**ADDENDUM NO. 01**

**GREATER BINGHAMTON AIRPORT**

**Rehabilitation of Hangars 2&3 – Phase 2**

**M-J PROJECT NO.: 01.19090.06**

(6) Drawing A-102 Floor Plans – Offices

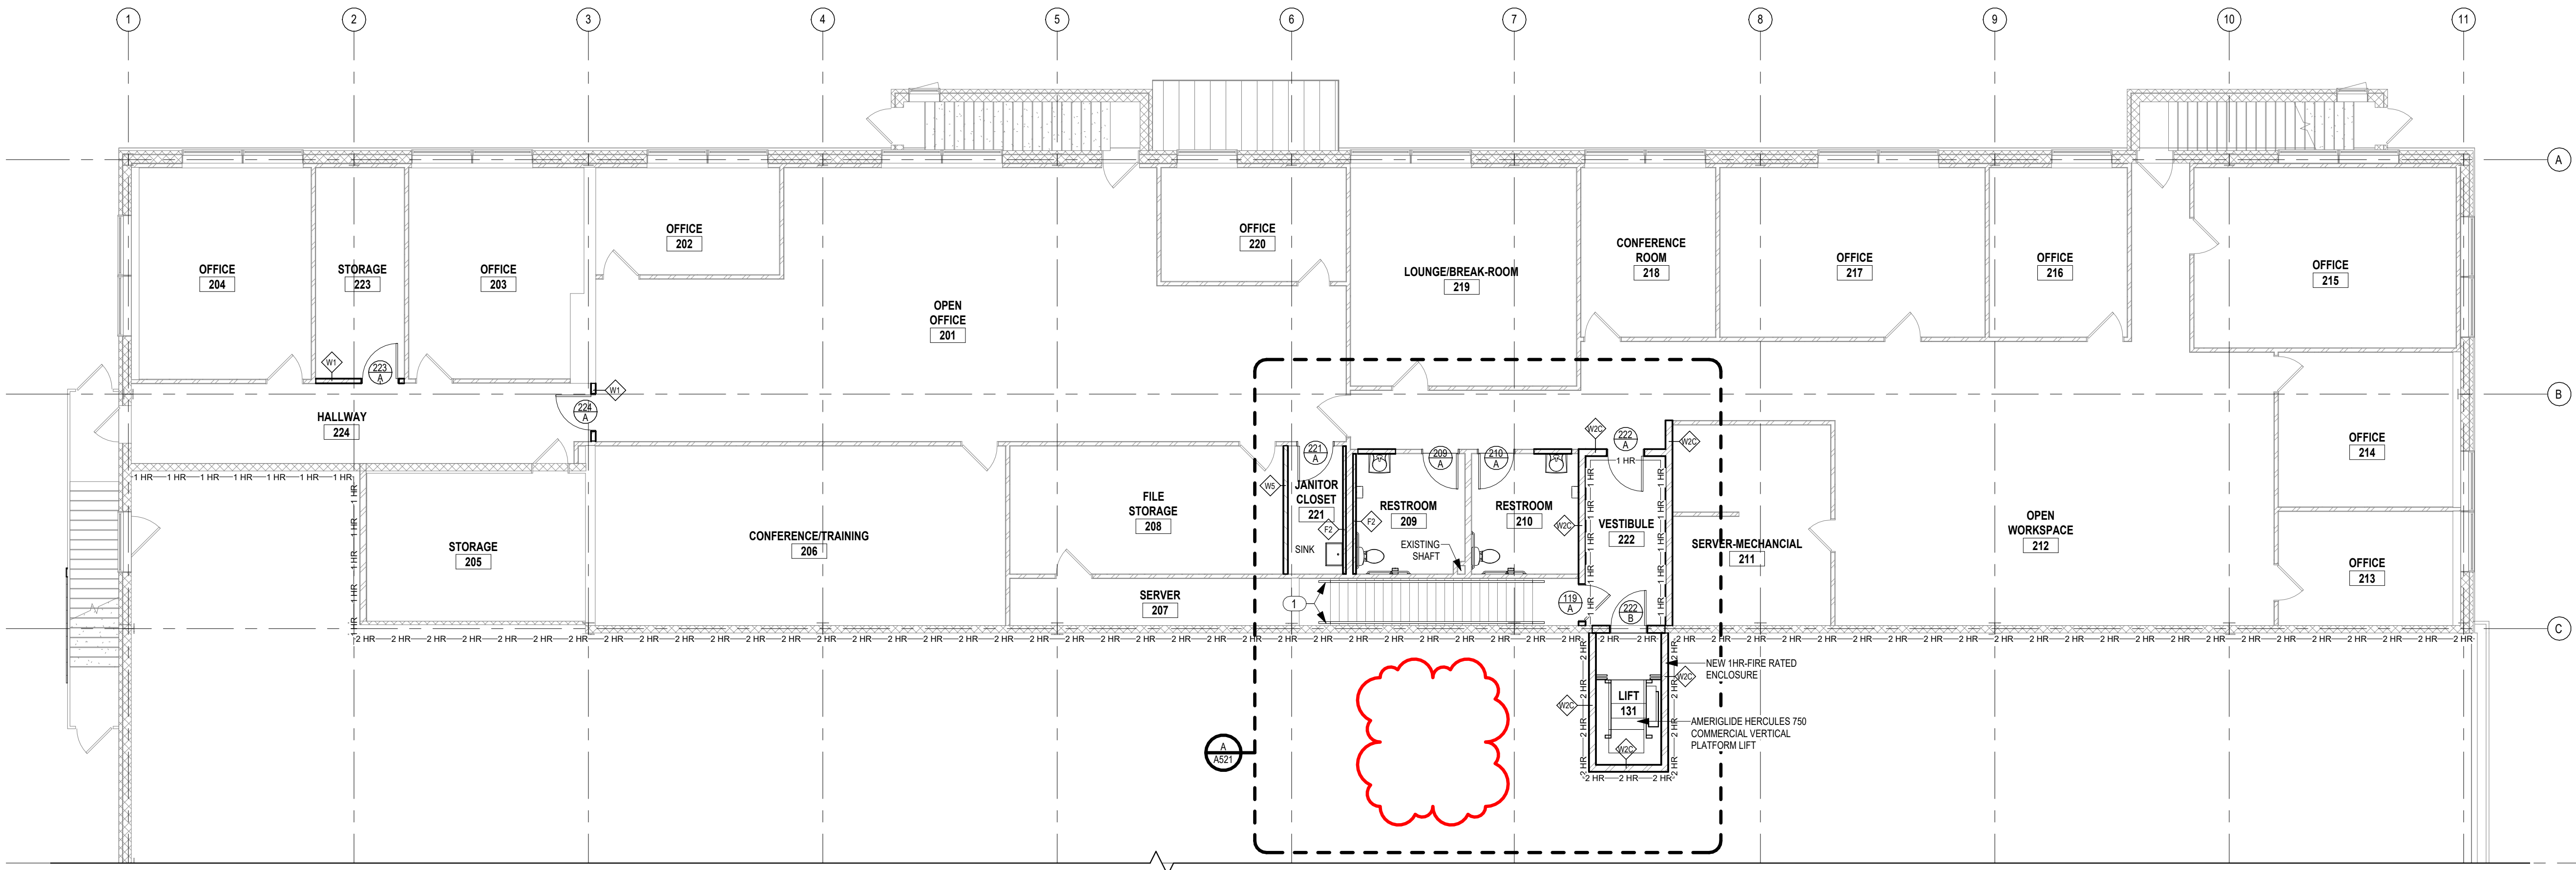
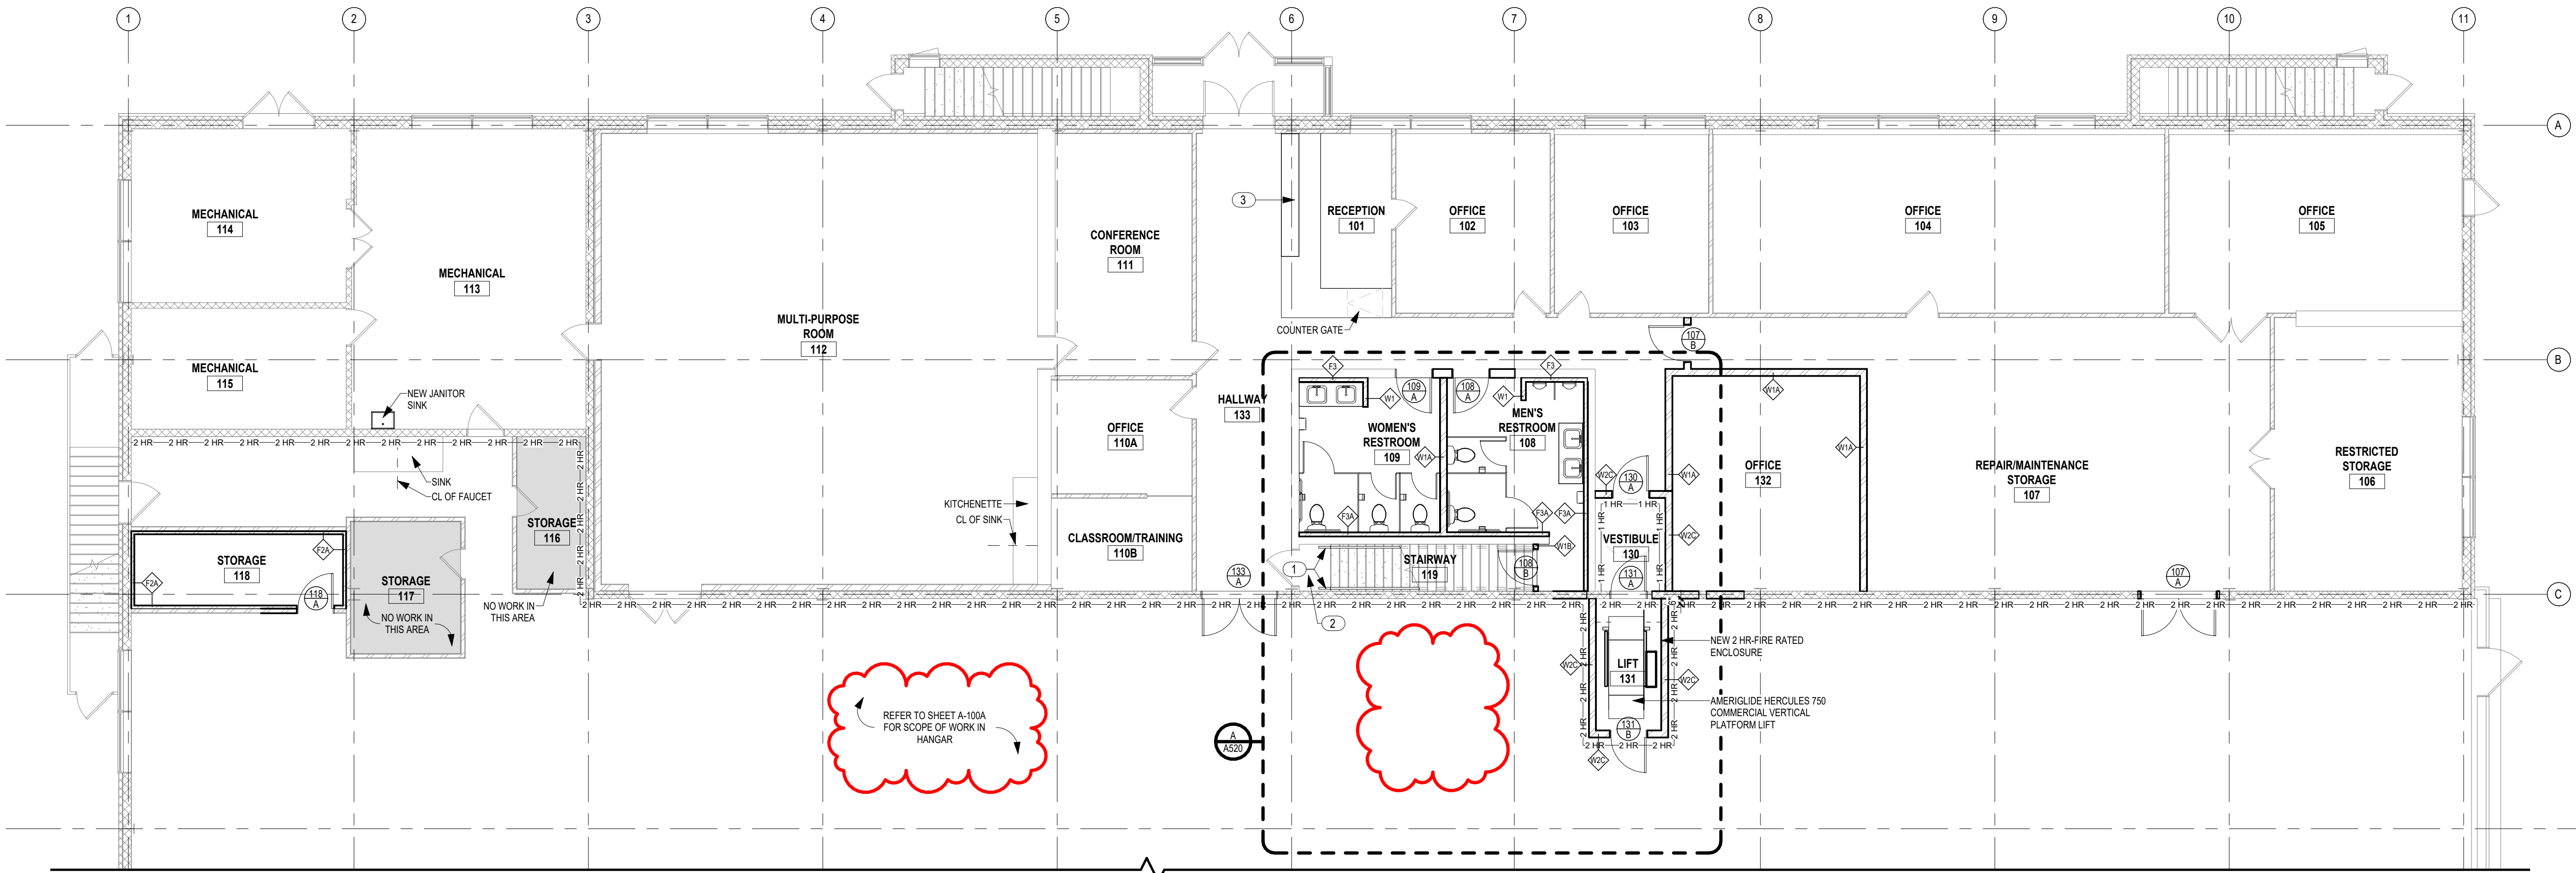
REPLACE Drawing A-102 in its entirety with the attached Drawing A-102A (Removed Mechanical Room)

A-500A

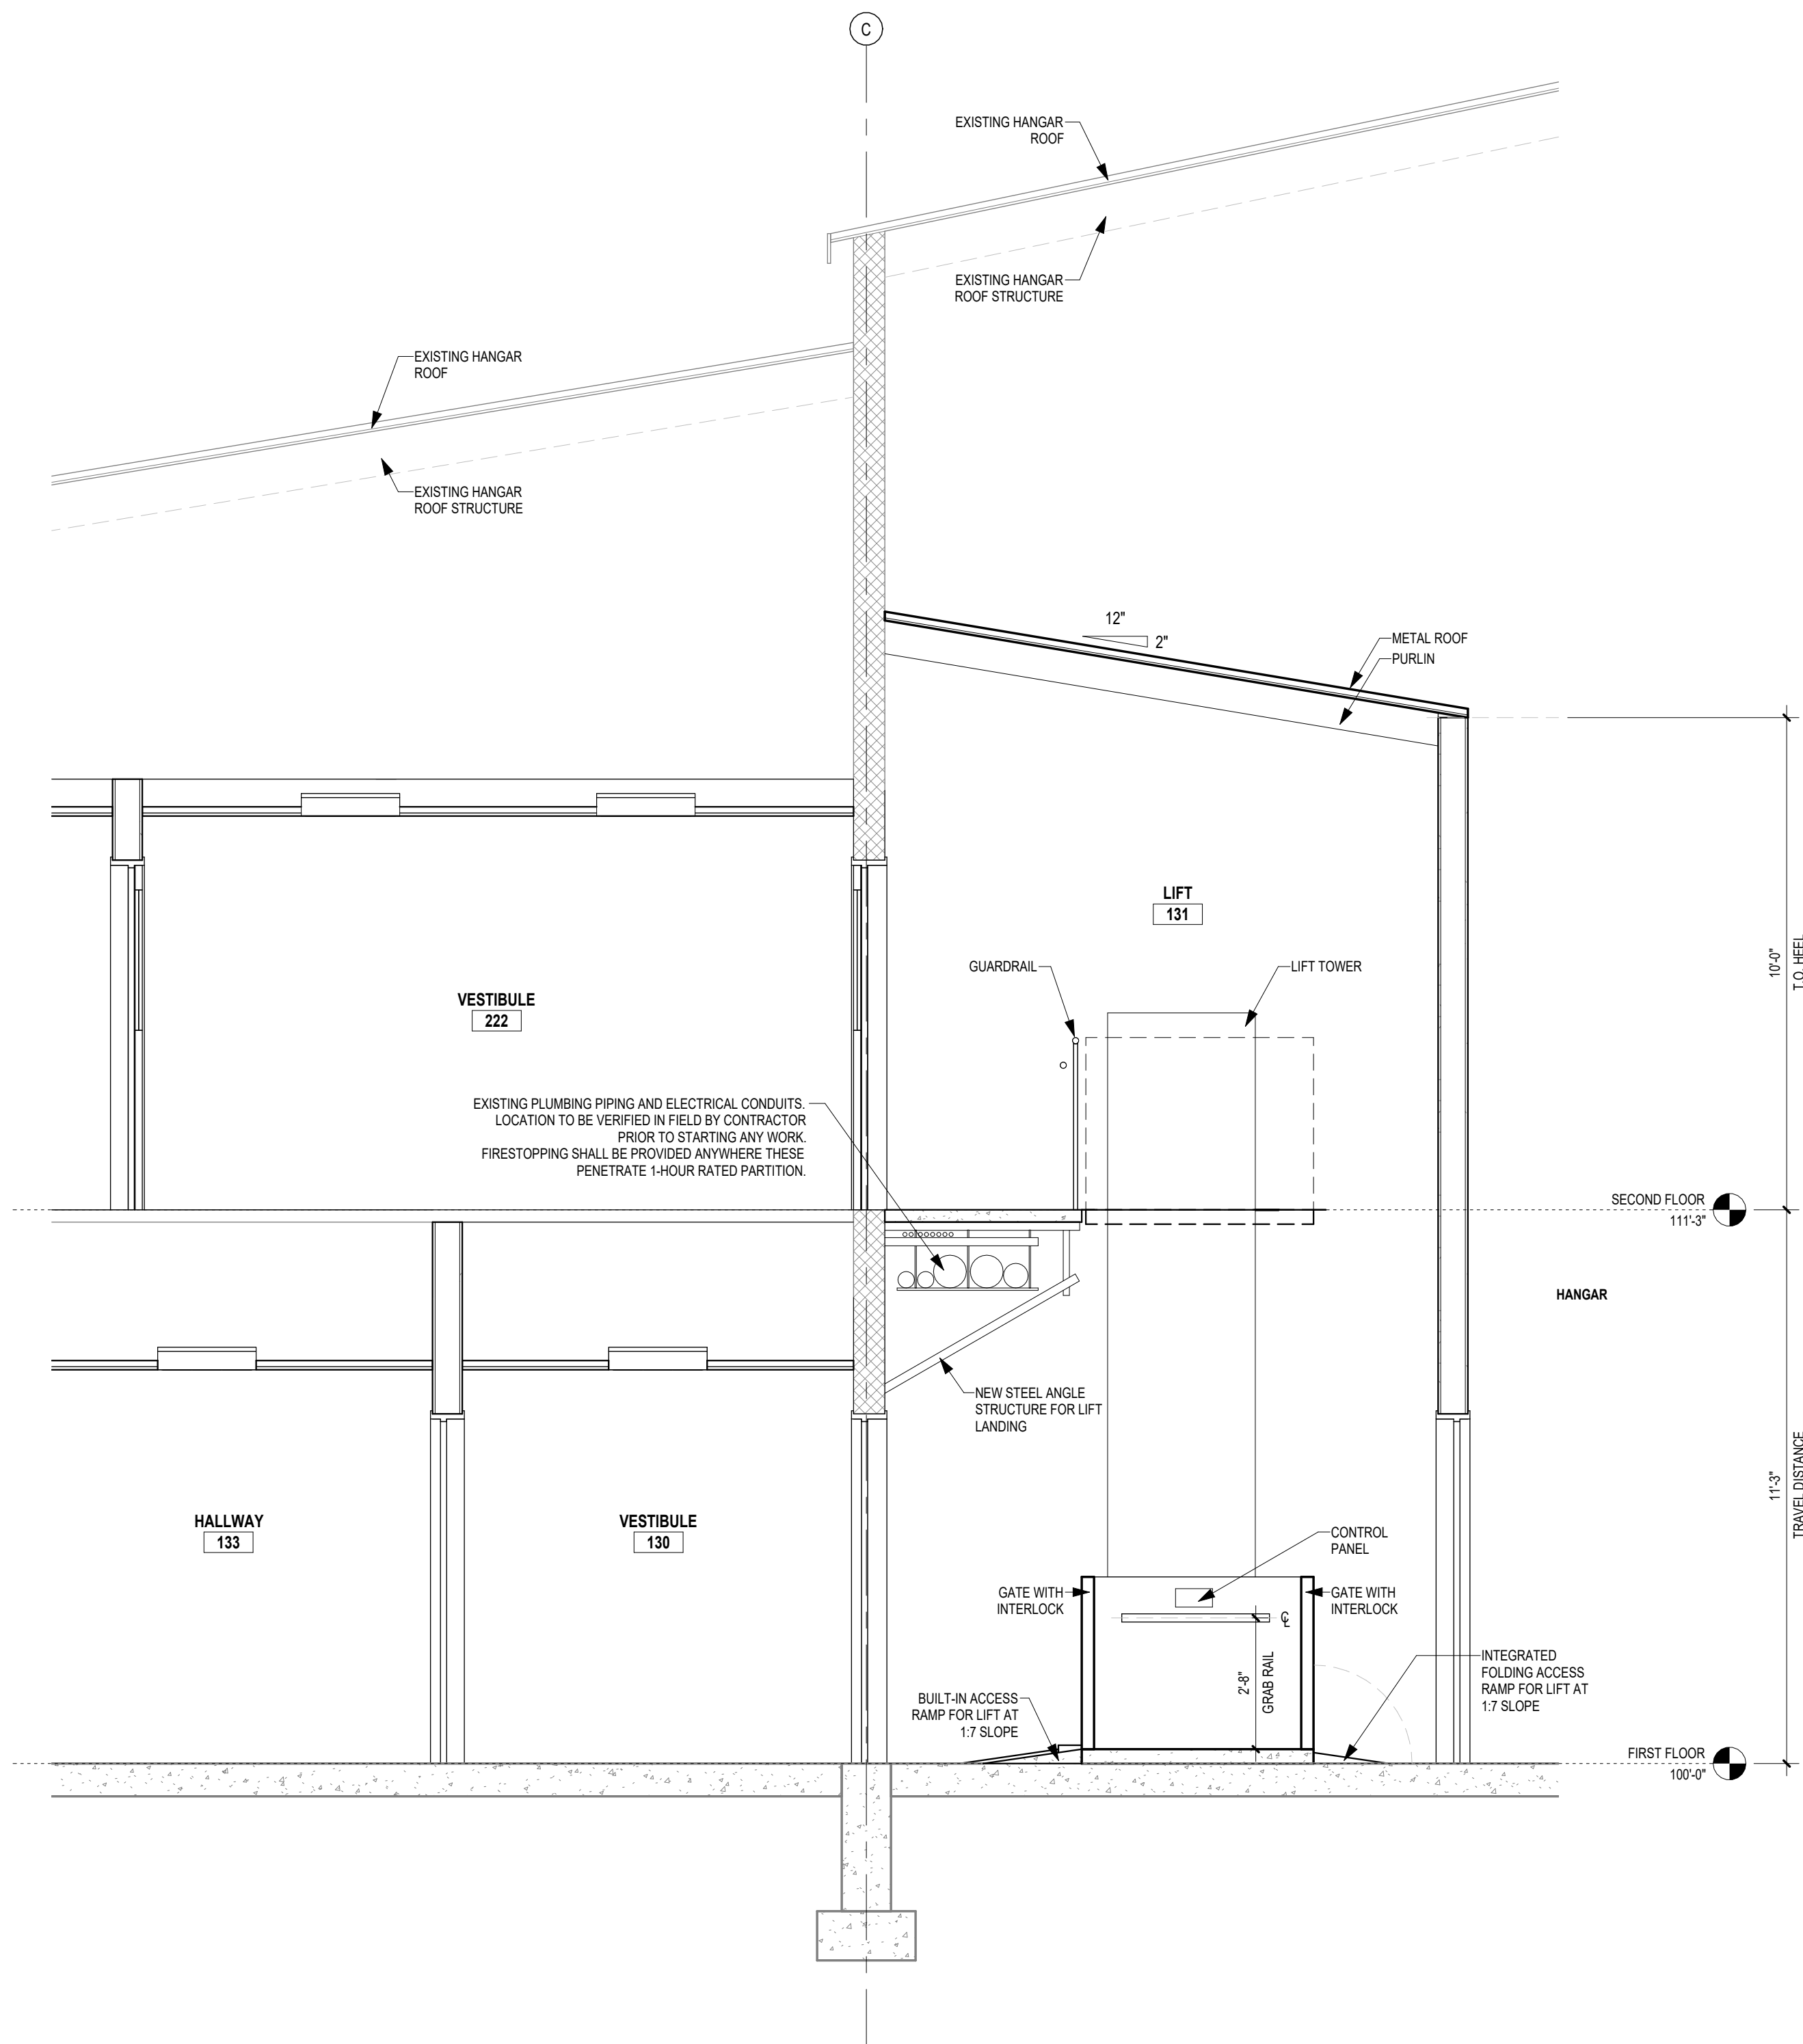
REPLACE Drawing A-500 in its entirety with the attached Drawing A-500A (removed Mechanical room)
